**Re: SDC/WSDOT Collaboration for urban design principles-Portage Bay
phase of SR 520 'Rest of the West'**

SDC recommendations for the Portage Bay Bridge and Montlake Lid

Image 8: Above bridge appurtenances (top) & bridge architectural features (bottom)

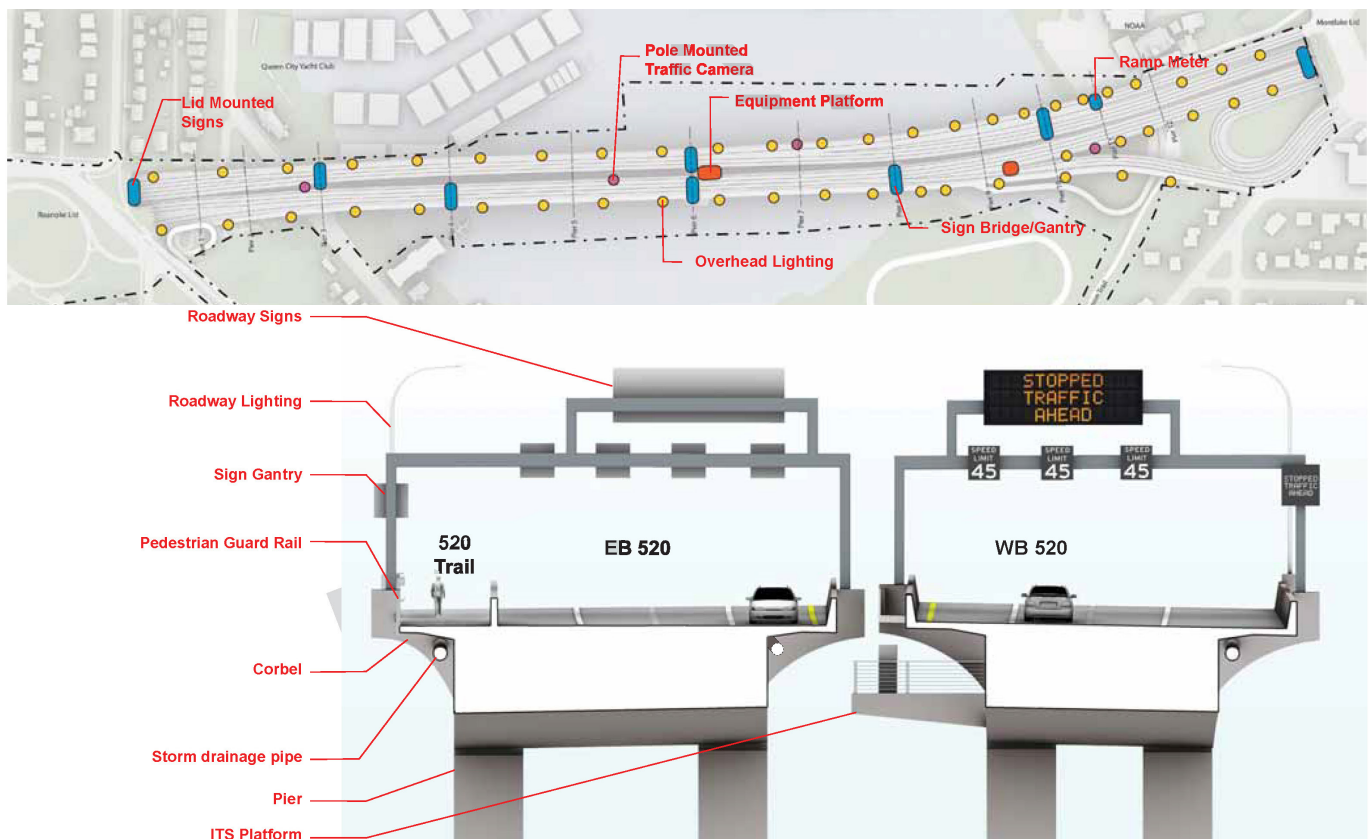
- The rhythm created by organizing the bridge appurtenances and architectural components to provide a higher aesthetic experience to those looking at and travelling along the bridges (see image 8)

The use of color in concrete and its application can reduce the appearance of structure mass and density. Colors should be chosen and applied in a manner that will reduce the overall bridge bulk and mass and streamline its appearance. Signage and lighting on the bridge should consider using coordinated color or metal type for signage and lighting to provide distinction from the rest of the corridor and to contribute to the overall quality of the bridge design.

1. Require handrail lighting along the bridge deck and related connections
2. Provide an incentive for an enhanced lighting concept
3. Investigate the use of color to offset the bridge mass and bulk
4. Provide guidance that elevates urban design solutions for highway signage, in addition to meeting industry and governmental standards
5. Consider requiring the design-builder to engage a nationally recognized bridge architect for final design of the bridge and SR 520 trail connections

Figure 2: Bill Dawson Trail underbridge design proposal

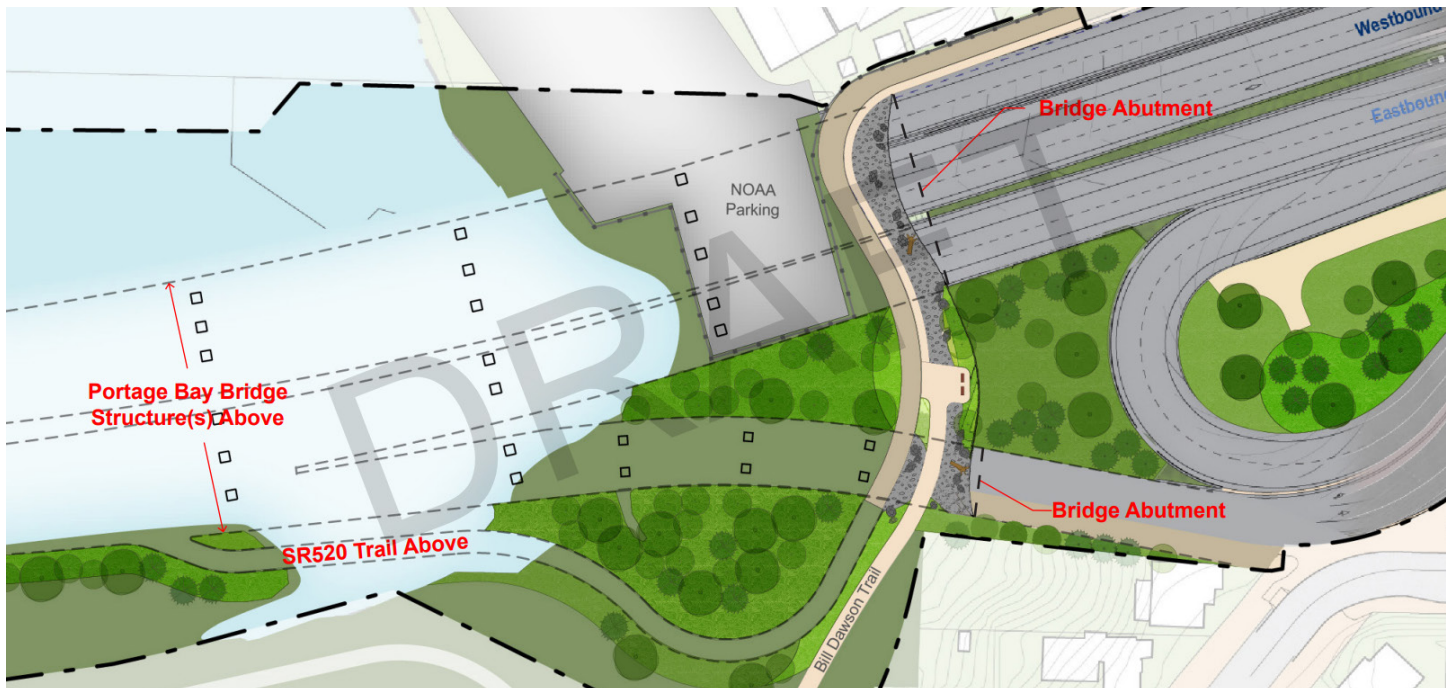
10. Continue to explore the width and materiality of the pedestrian portion of the Bill Dawson Trail to support a of hierarchy of use and to provide solutions to ensure the pathway provides the right amount of space for both cyclists and pedestrians

12. Increase the sidewalk width and provide options to improve safety near the turn with low visibility on the Bill Dawson Trail

Figure 2: Updated design proposal for the trail network (top), Portage Bay Bridge (middle), and Roanoke Lid (bottom)

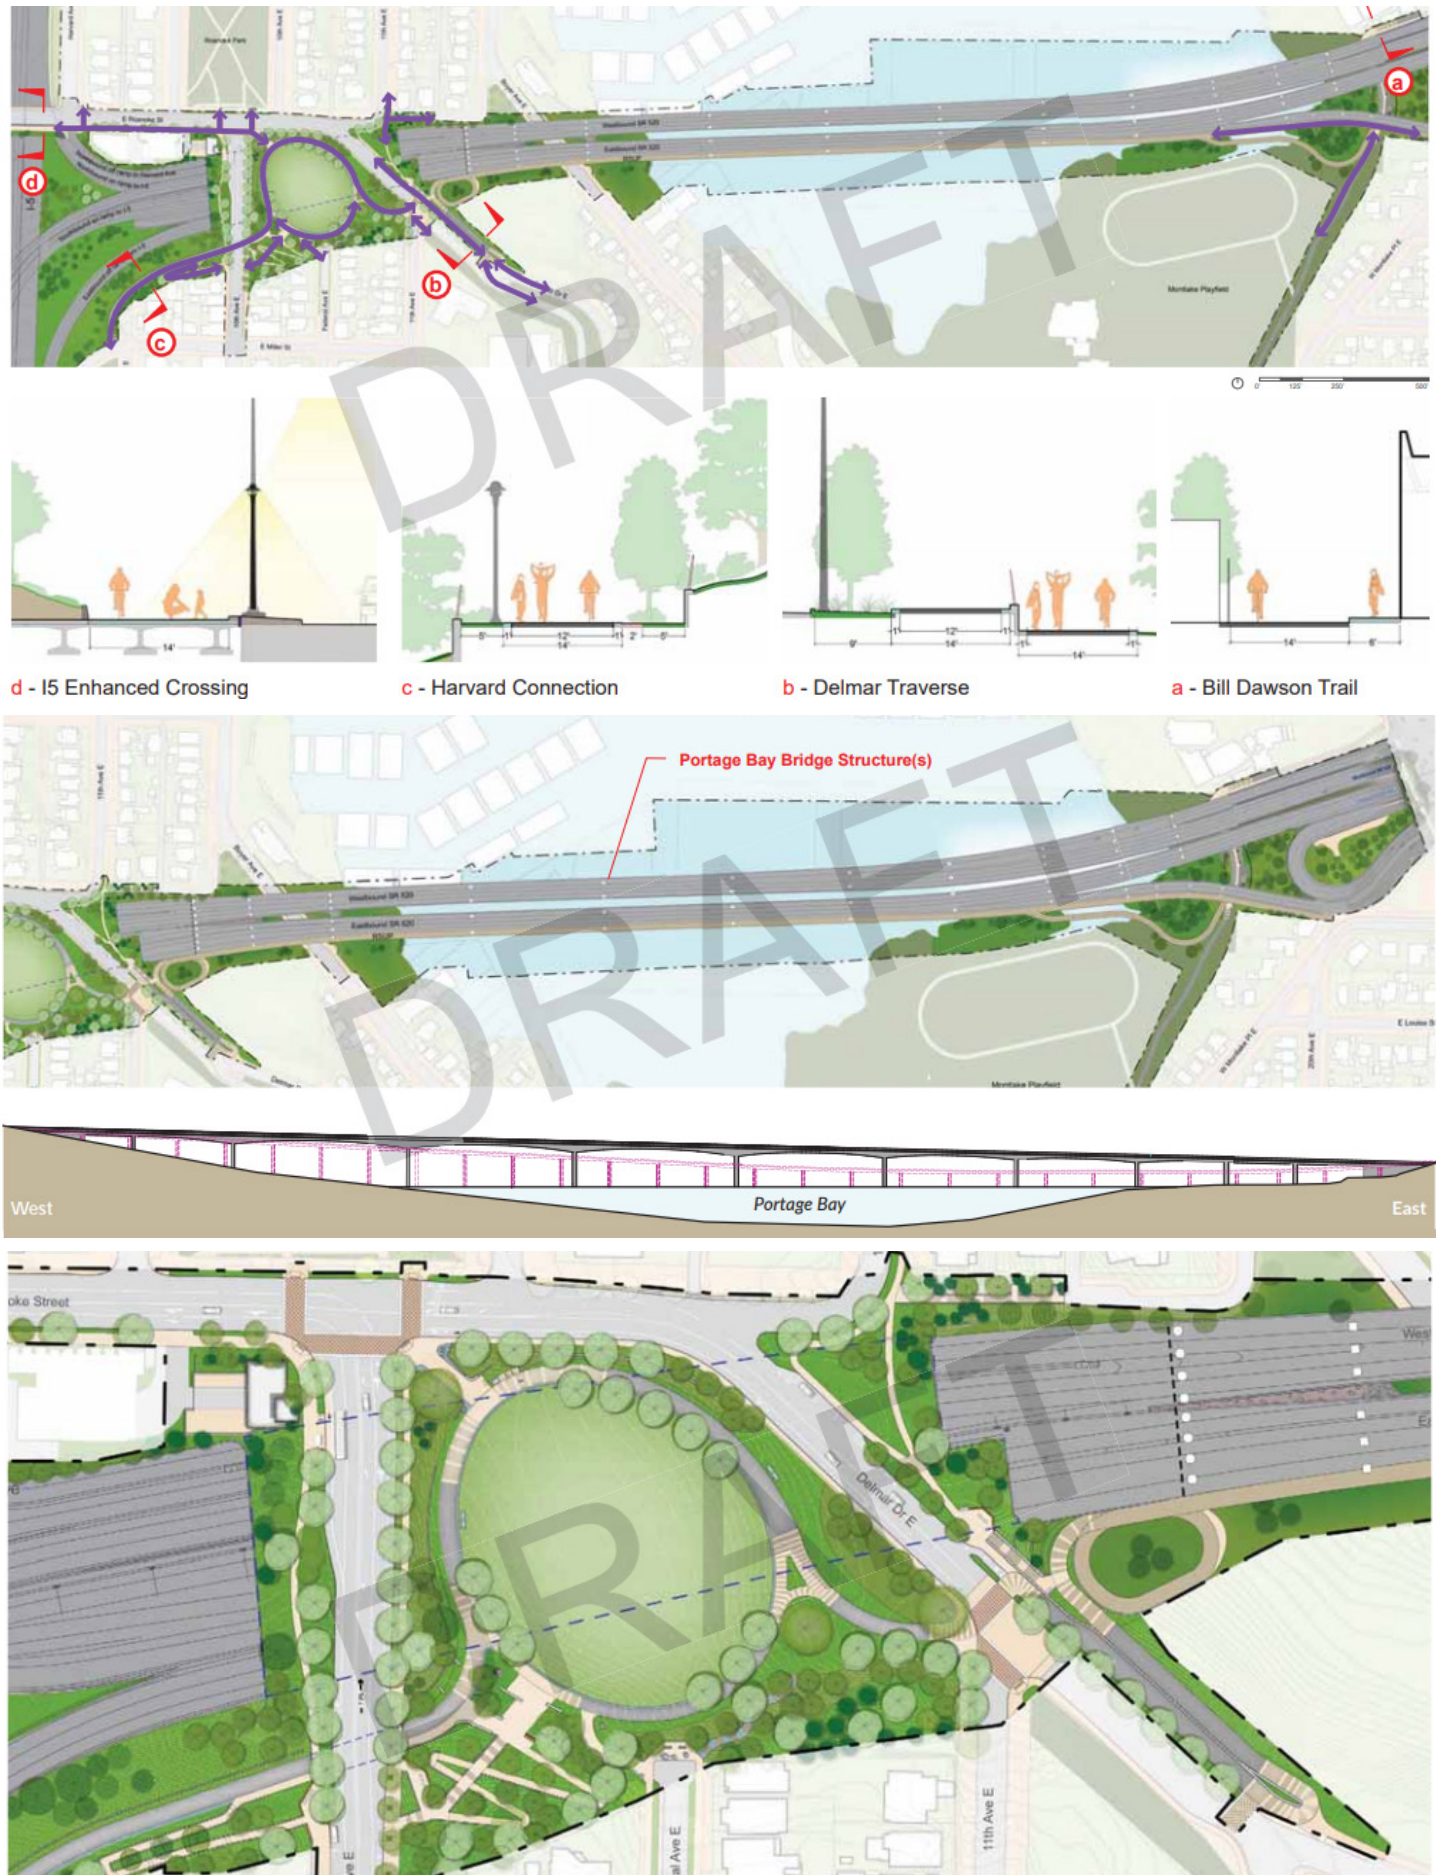
The SDC discussed the proposed layout and design of the ground plane of the Bill Dawson underbridge area. Commissioners had differing opinions on how the proposed boulders and rocks are located within the landscape but agreed that prescriptive language should be in the RFP that elevates the location of boulders and rocks as a specific design element. Language should also address the design approach and level of quality of the boulders and rocks. Commissioners also suggested the project team consider using some of the ground plane materials to buffer the pedestrian path.

Commissioners commented that the proposed lighting elements are hidden within the bridge girder, resulting in a soft light. Commissioners also recognized that the soft light is a result of the soft finish applied to the girder and strongly recommended the project team include carry this forward into the RFP. The commission then recommended the project team specify a variety of planting and tree species within the proposed restoration area to increase the long-term resiliency.

The SDC then discussed issues around the one bridge alternative. The Commission stated that a one bridge alternative would need to maintain the overall project vision. Commissioners also stated that if a one bridge alternative is proposed the project team should provide an explanation of benefits of the one bridge alternative, beyond addressing the project schedule and budget.

The SDC commended the project team for the proposed design of the Roanoke Lid. Specifically, commissioners commended the team for not providing specific programming, instead setting up a framework for how the park will be used and grow in the future. The SDC also appreciated the location of topographical changes, which allows the central lawn to better function as open space and recommended that this design be kept moving forward. Commissioners also appreciated that the design proposal provided connections to parks and boulevards created in the original Olmsted plan. The SDC encouraged the project team to continue to think about visual and physical connections as the design evolves. Commissioners also stressed the importance of developing each viewpoint or overlook with a unique character, scale, and view. Commissioners recommended the location, scale, and orientation of each overlook and viewpoint be prescribed in the RFP.

The SDC recognized that the proposed design will provide different experiences along 10th Ave E and Delmar Dr. and strongly encouraged the project team to provide street crossings that are multimodal and sized appropriately. The Commission then recommended that the project team provide a safety plan for users crossing 10th Ave E near the southwest corner of the park. Commissioners also recommended providing runnels on staircases for cyclists.

2. The recessed lighting under the bridge as well as the material finish the girder to provide soft lighting to the Bill Dawson Underbridge area.
3. Maintain the design and location of each mixing zone in the Bill Dawson Underbridge area, requiring an explanation for any design changes.

4. Specify a variety of planting and tree species within the proposed restoration area to increase the long-term resiliency in the Bill Dawson and Boyer Underbridge areas

8. Grading of the Roanoke lid to facilitate usable open space
9. Location, scale, and orientation of proposed overlooks on the Roanoke Lid
10. Additional criteria for providing design alternatives to be included in the RFP to provide better understanding as to what alternatives should include
